Municipal Solid Waste Permit Amendment No. 1848A
 Beck Landfill
 Fifth Notice of Technical Deficiency

MUNICIPAL SOLID WASTE PERMIT MAJOR AMENDMENT-5TH NOD RESPONSE

NAME OF PROJECT: Beck Landfill

MSW PERMIT APPLICATION NO.: 1848A

**NIDO, LTD
 BECK LANDFILL
 FIGURE E-9
 SEISMIC IMPACT ZONE MAP -
 REGIONAL SCALE
 SCHERTZ, GUADALUPE
 COUNTY, TEXAS**

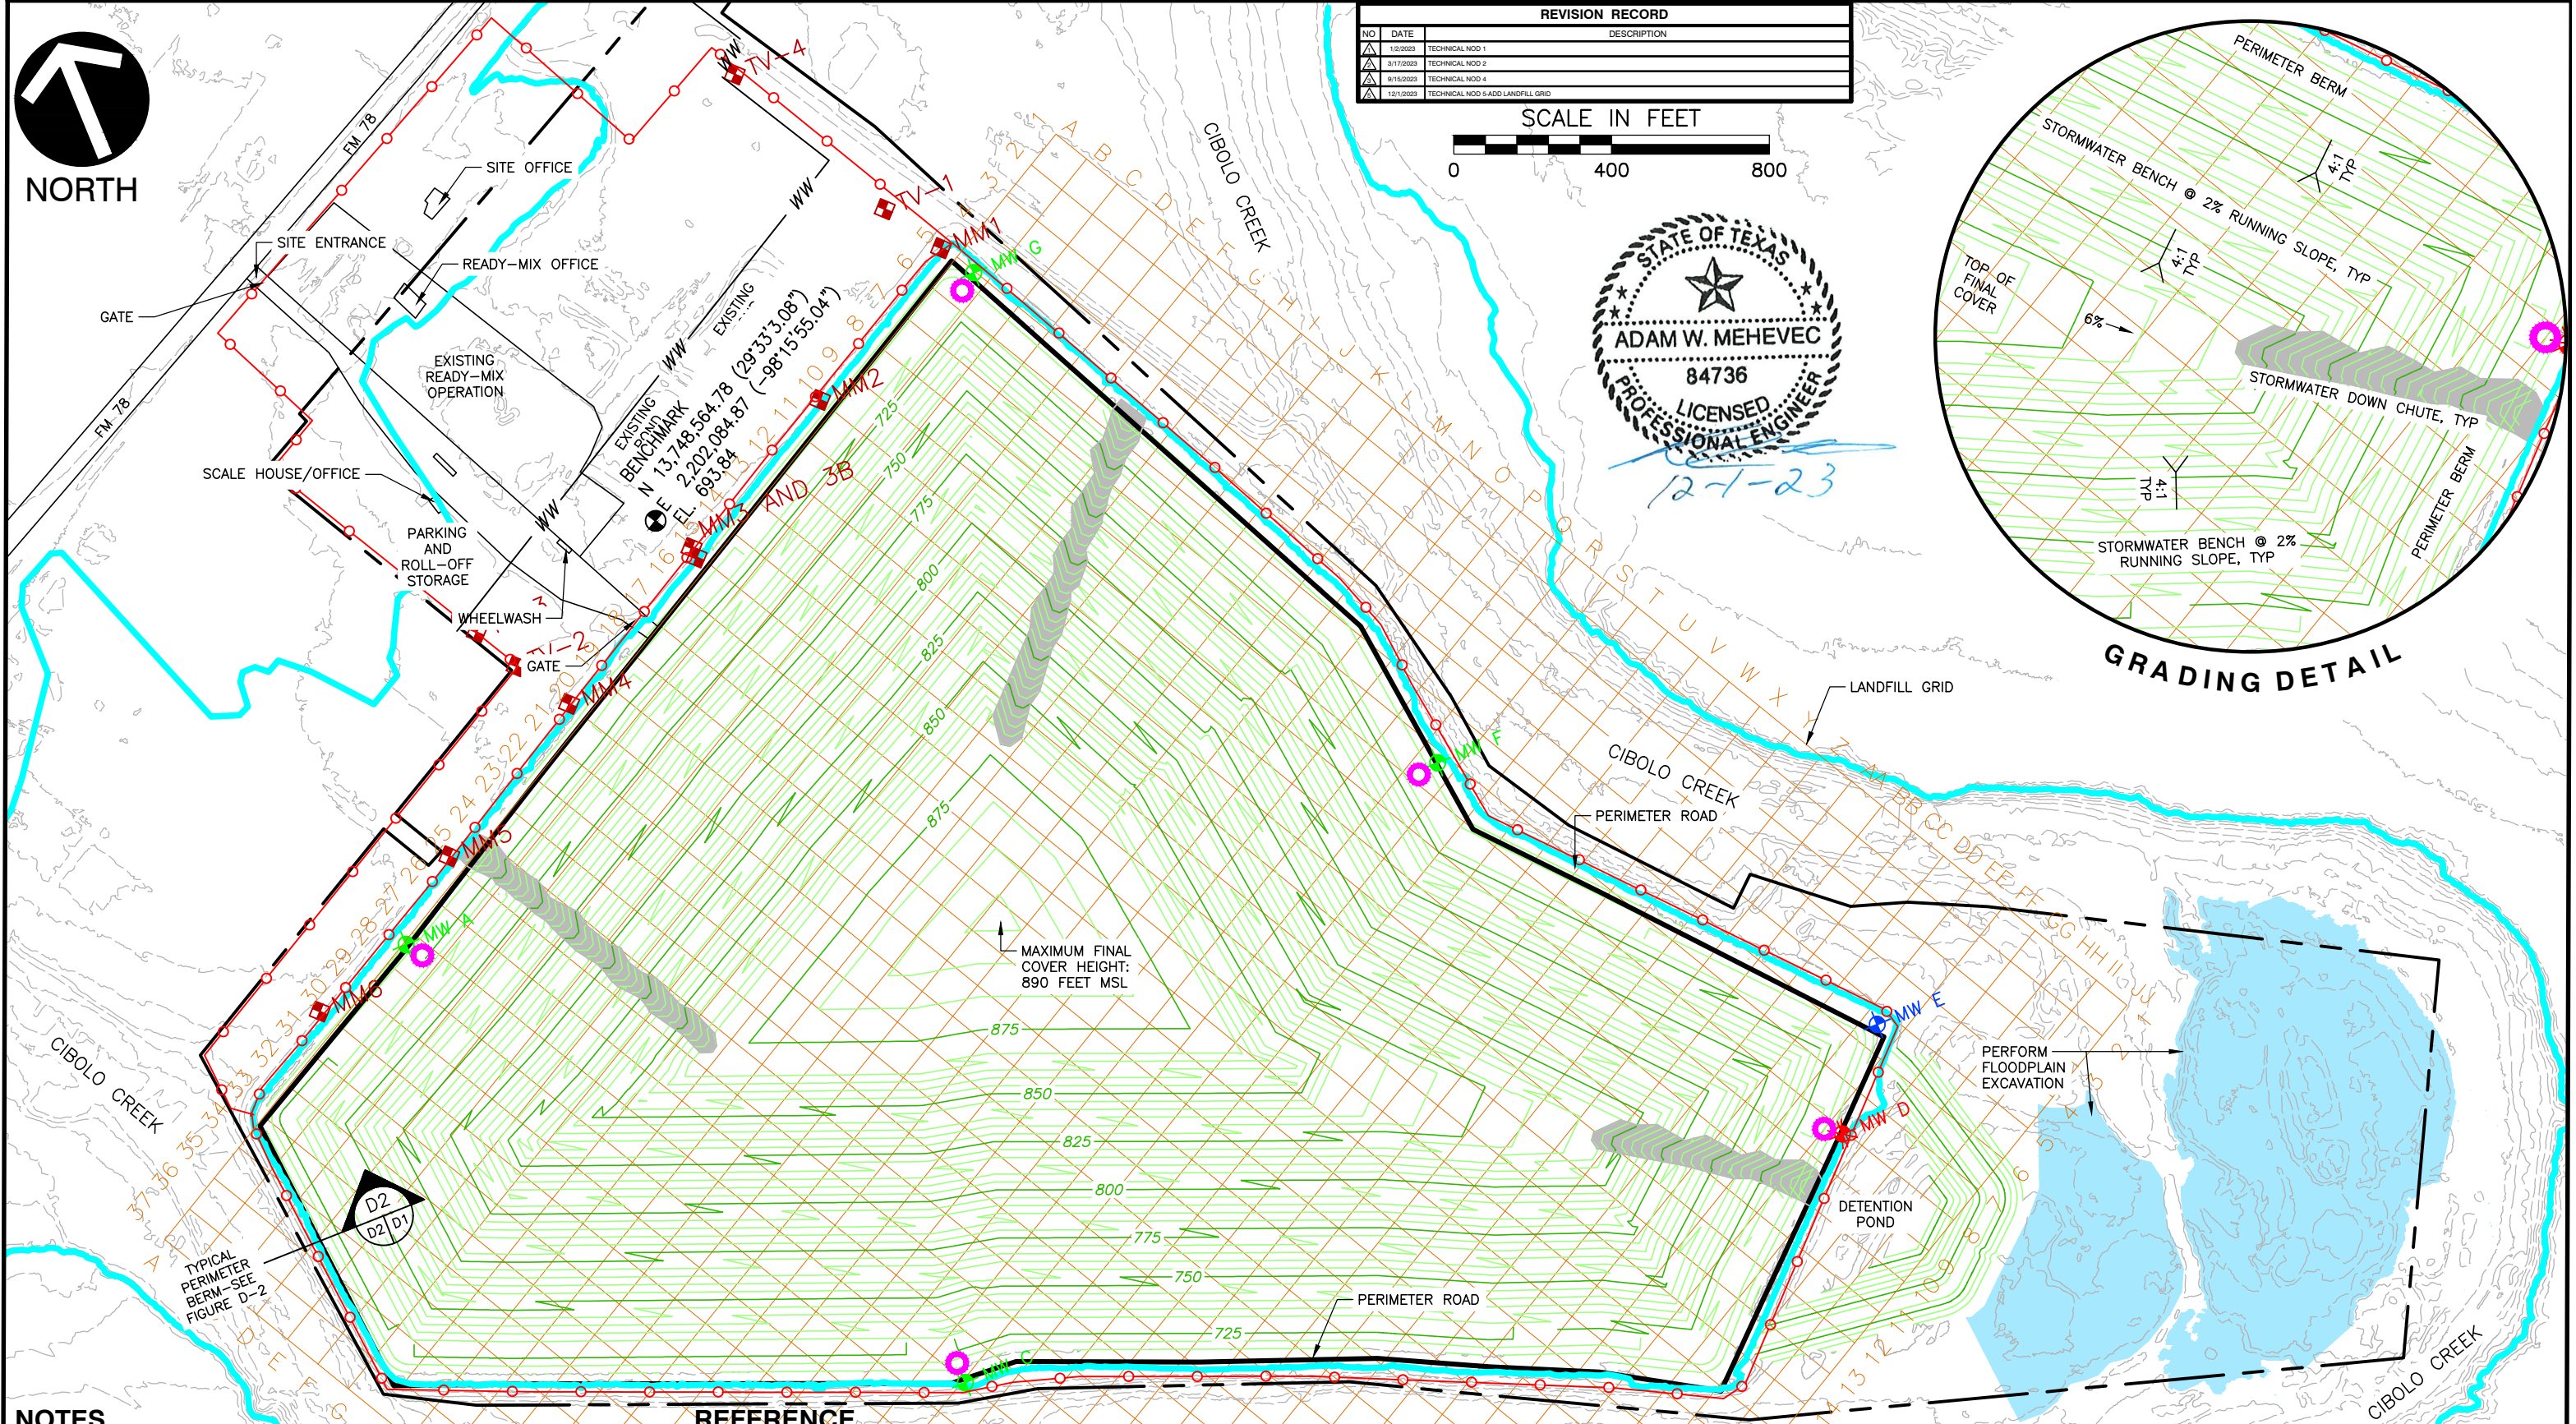
NOD ID	MRI ID	Application Part	Citation	Location	NOD Description	Response
1	22	General	330.57(g)(3)	Master Table of Contents	In the application master table of contents, correct the entry for Part III, Attachment C2, Appendix C2-3 to indicate appendix is C2-C.	The master table of contents has been updated with this change.
2	89	Part I	330.59(d)(2)	Attachment 6	Provide signed and notarized property owner affidavits with the NOD response. Use the form on page 13 of the Part I application form dated 10/24/23, available at https://www.tceq.texas.gov/downloads/permitting/waste-permits/msw/forms/00650.pdf .	A signed and notarized property owner affidavit is provided.
3	150	Parts II and III	330.61(j)(3), 330.63(e)(2), and 330.557	Part II, Attachment G, and Part III, Attachment E, Figure E-9	Provide a legible copy of the USGS seismic hazard map on Page G-5 in Part II, and a copy of the same map in place of current Figure E-9 in Part III, Attachment E.	The map on Page G-5 can not be modified to be legible at the page scale, so the same map is provided in place of Figure E-9 in Attachment E.

FIGURE ABOVE DEPICTS THE BALCONES FAULT ZONE AND THE LOCATION OF THE BECK LANDFILL (STAR) LOCATED TO THE SOUTH.

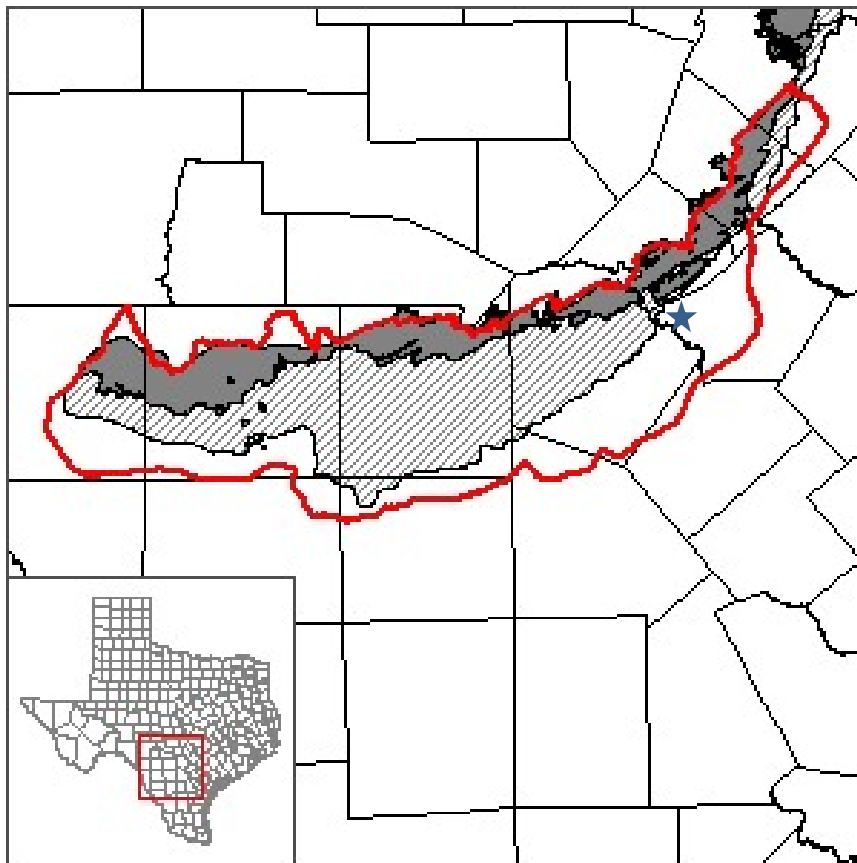
4	183	Part III	330.61(d) and 330.143(b)(5)	Attachment D1, Figure D1.1	Revise the site layout map to show the landfill grid system, with labels.	A revised copy of Figure D1.1 has been provided which includes the landfill grid.
5	335	Part III	330.63(c)(2)(D)	Attachment C2	Provide a Letter of Map Revision (LOMR) from FEMA.	The LOMR is still under review by FEMA and we will provide the approval as soon as it is available.
6	476	Part III	330.63(e)(2)	Attachment E	Delete "(Cretaceous)" from the last sentence of Section 1.1.	This edit has been made.
7	476	Part III	330.63(e)(2)	Attachment E	Revise the figure, and narrative, inserted in Section 1.2 to show the facility in its correct location in Guadalupe County.	The figure and narrative are revised.
